STAFF REPORT

DRCC #:19-3406C

PROJECT NAME: Pillar of Fire International -- Proposed Parking Area Expansion

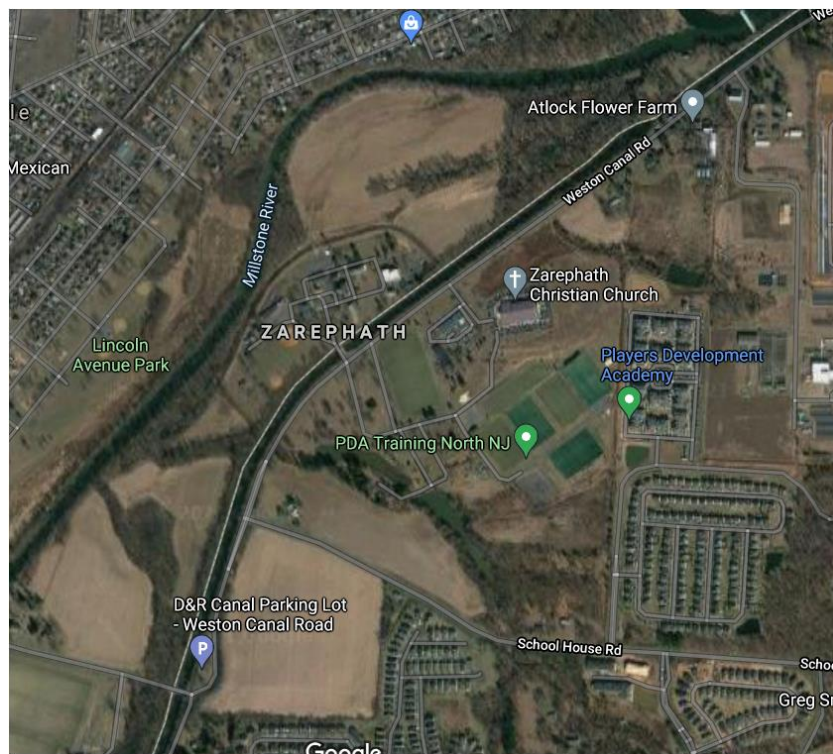
Proposed Project: The applicant proposes to expand the existing House of Worship (see aerial image below) paved parking area to accommodate approximately 244 additional parking spaces. The site currently has 251 parking spaces so the proposed future parking will accommodate a total of 475 parking spaces. A 4,860 square foot (0.11 acre) portion of the proposed parking will consist of pervious pavement. As part of the project, an existing emergency access driveway will be realigned and a light pole on the east side of the building will be relocated.
